National Committee on Uniform Traffic Control Devices

National Committee on Uniform Traffic Control Devices (NCUTCD) Recommended Changes to Proposed Text for 11th Edition of the MUTCD Docket Number: FHWA-2020-0001

6 **Federal Register Item Number:** 419-424 (see listing below)

7 **NPA MUTCD Section Number:** Chapter 4I

218 **Figure 4I-2. Pushbutton Location Area**

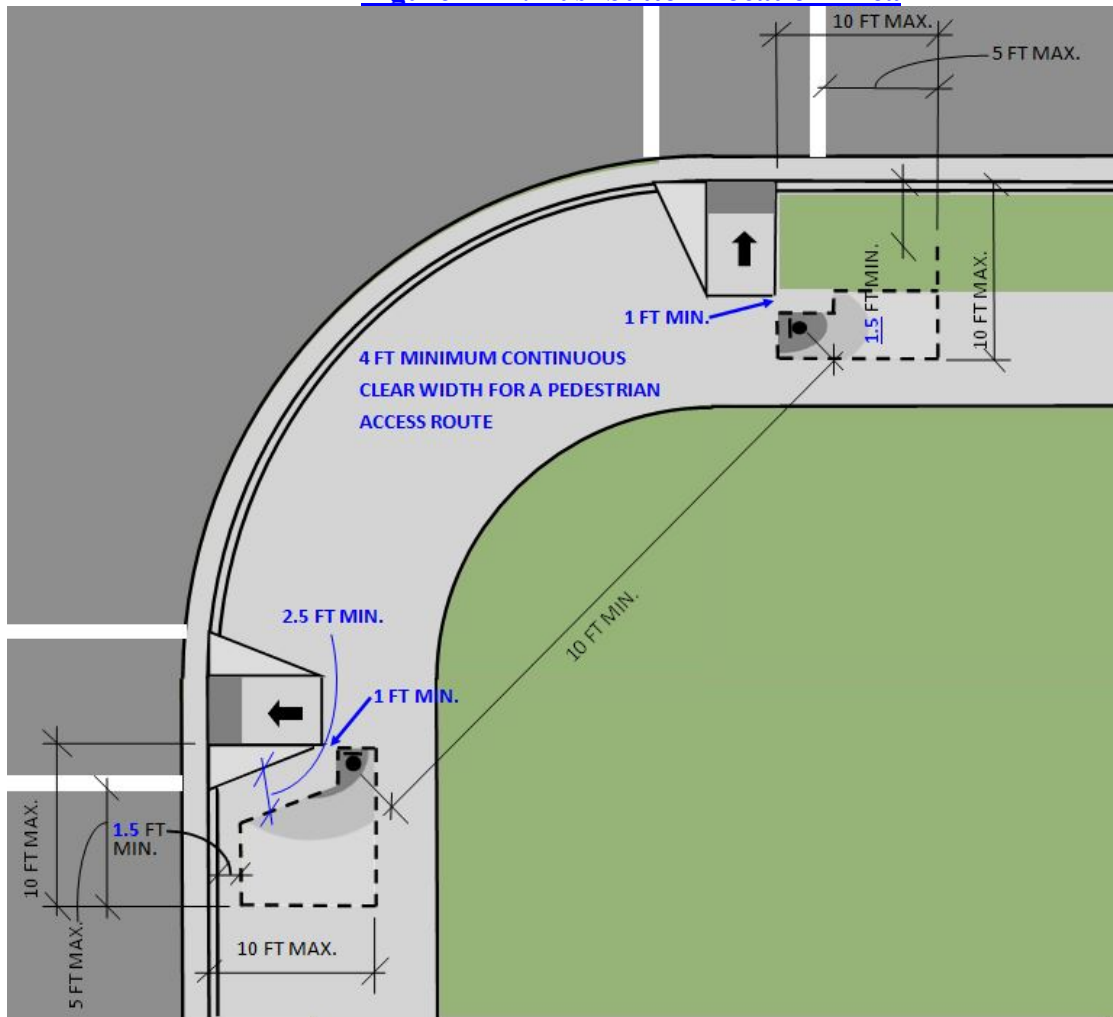
216 **Figure 4I-2 Comments:** NCUTCD recommends deleting NPA Figure 4I-2 and replacing it with
217 two new figures.

225 **Figure 4I-X. Pushbutton Location Area**

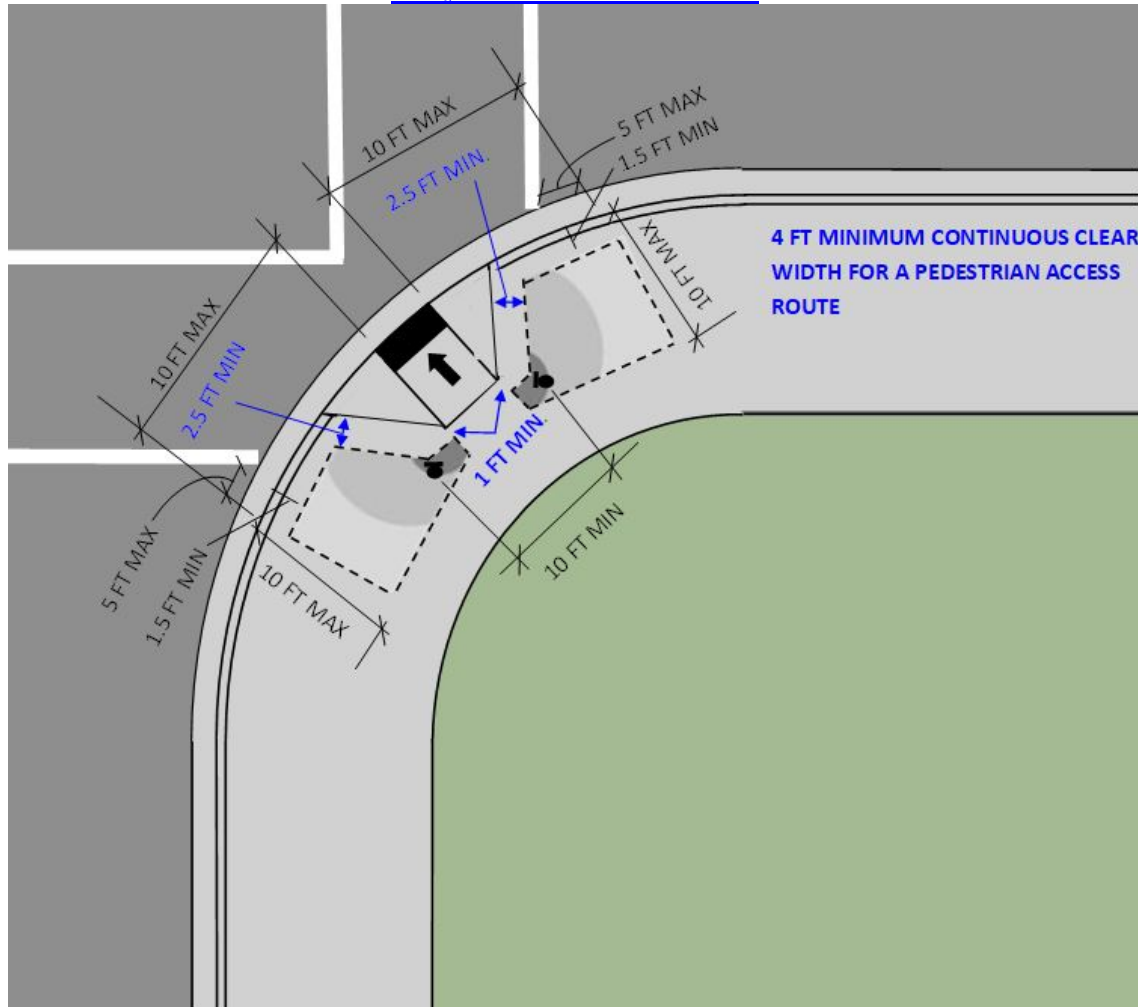
221 **Figure 4I-X Comments:** NCUTCD recommends adding a new Figure 4I-X to depict preferred
222 placement of pedestrian detection on street corners with a pedestrian access ramp for each
223 crosswalk to be consistent with existing MUTCD text and AASHTO clear zone requirements in
224 accordance with NCUTCD recommendation 20B-SIG-01.

1. [No greater than 5 feet from the outside edge of the marked crosswalk farthest from the center of the intersection.](#)
2. [Not farther from the crosswalk than the stop line, if present.](#)
3. Any maximum (MAX) or minimum (MIN) dimensions shown are based on Guidance Statements.
4. Two pedestrian pushbuttons on a corner should be separated by [a minimum of 10 feet](#). The 10-foot dimension shown in this figure is in reference to the [placement of the pushbuttons within their respective areas \(see 4I.05\)](#).
5. [All dimensions referencing the curb are measured from the face of curb.](#)
6. Figure [4I-4](#) shows typical pushbutton locations.

7. Allow a minimum 4-foot continuous clear width for a pedestrian access route.

8. 2.5 feet minimum from the side of the ramp wing and 1 foot minimum from the top of the ramp.
